The Commission has issued the enclosed Amendment No. 8 to Provisional Operating License No. DPR-18 for the R. E. Ginna Nuclear Power Plant. This amendment includes Change No. 17 to the Technical Specifications and is in response to your request dated December 2, 1974.

R. E. GINNA NUCLEAR POWER PLANT

Amendment No. 8  
License No. DPR-18

ATTACHMENT TO LICENSE AMENDMENT NO. 8  
CHANGE NO. 17 TO THE TECHNICAL SPECIFICATIONS  
PROVISIONAL OPERATING LICENSE NO. DPR-18  
DOCKET NO. 50-244

FIGURE 6.2-1

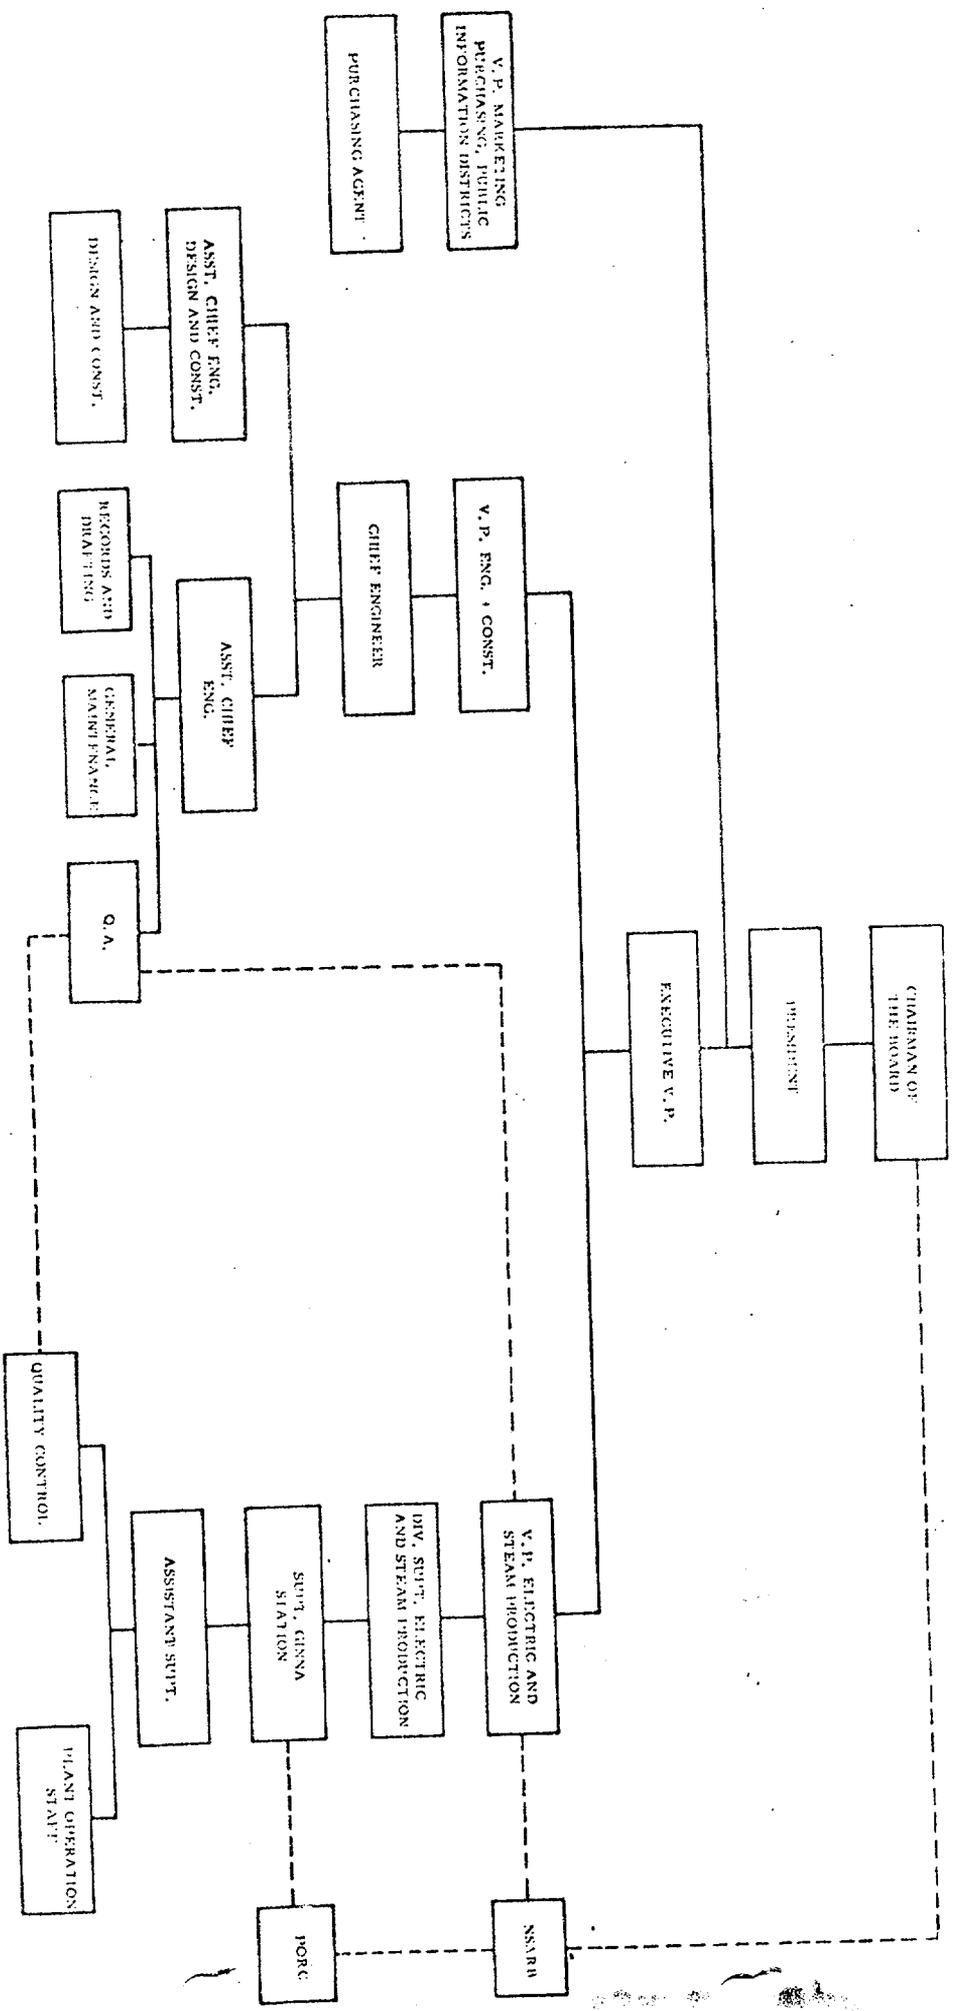
6.2.1 The offsite organization for facility management and technical support shall be as shown on Figure 6.2-1.

Figure 6.2-2

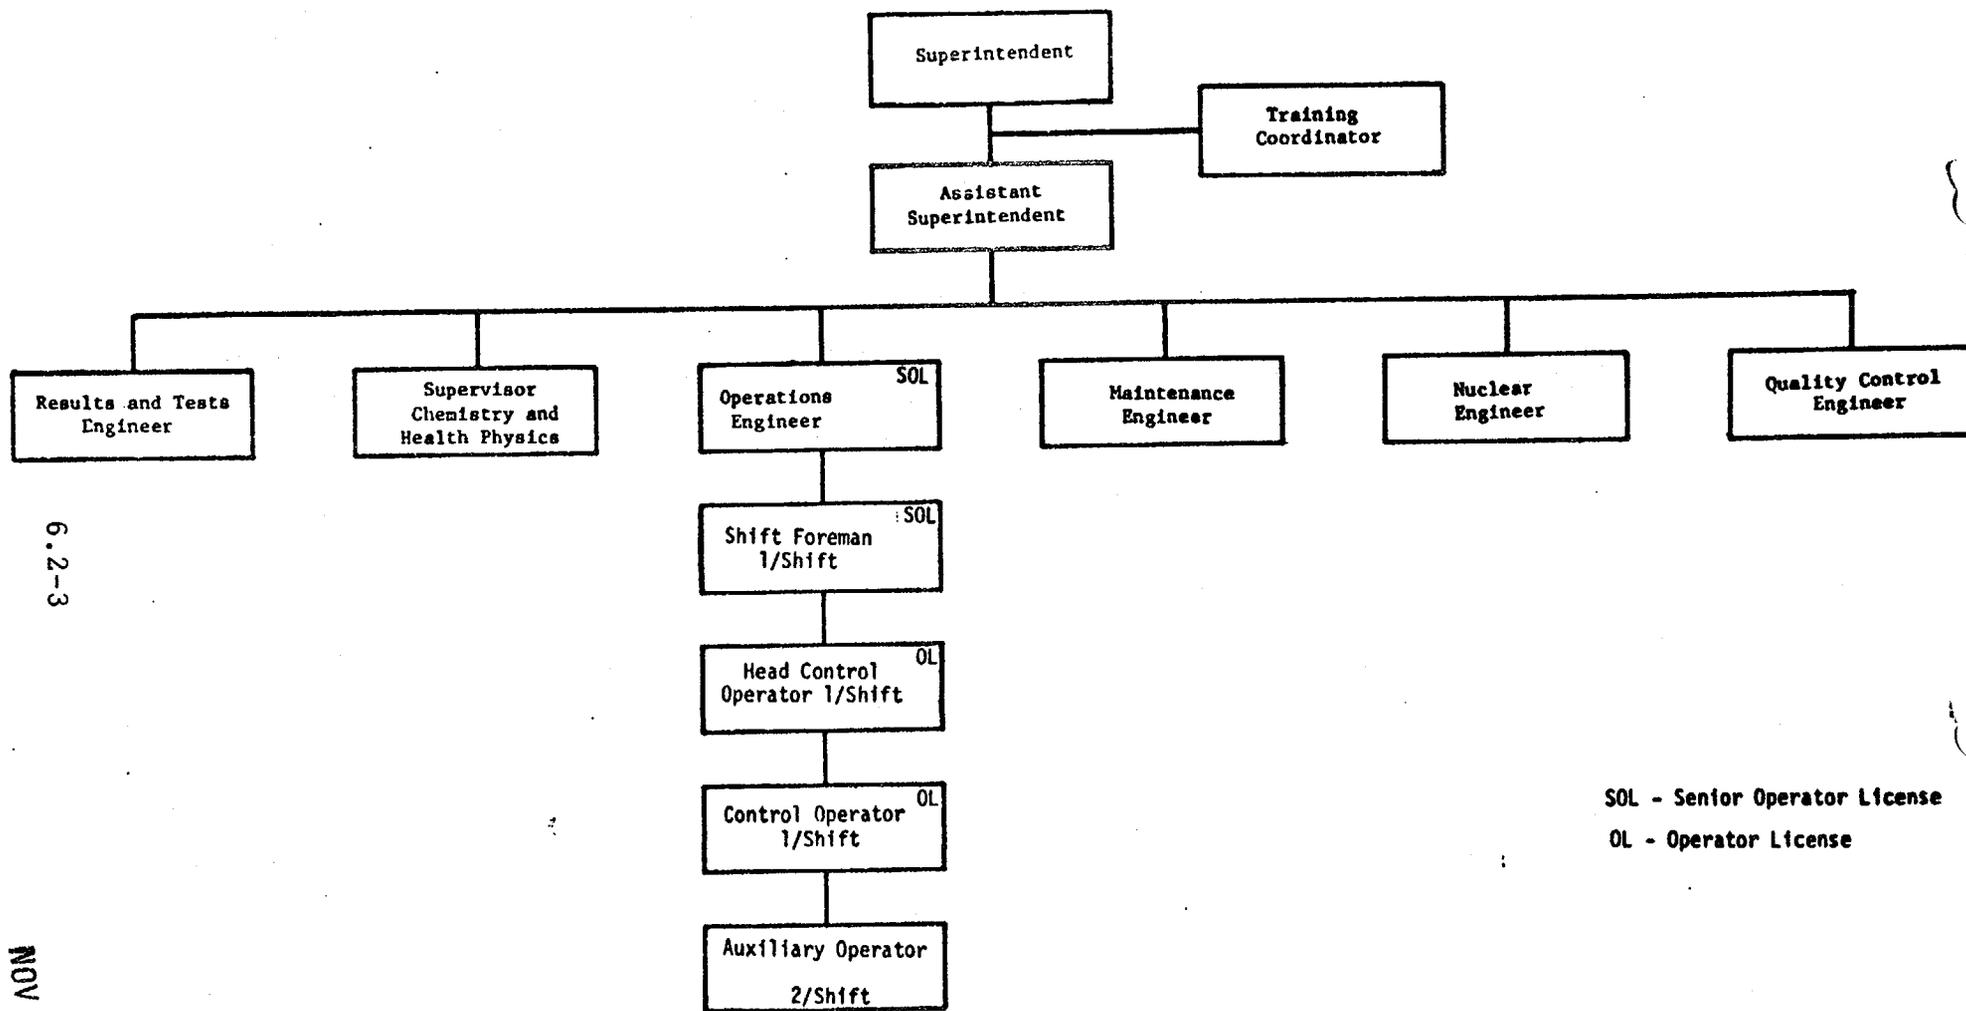
6.2.2 The Facility organization shall be as shown on Figure 6.2-2 and:

- a. Each on duty shift shall be composed of at least the minimum shift crew composition shown in Figure 6.2-2.
- b. At least once licensed Operator shall be in the control room when fuel is in the reactor.
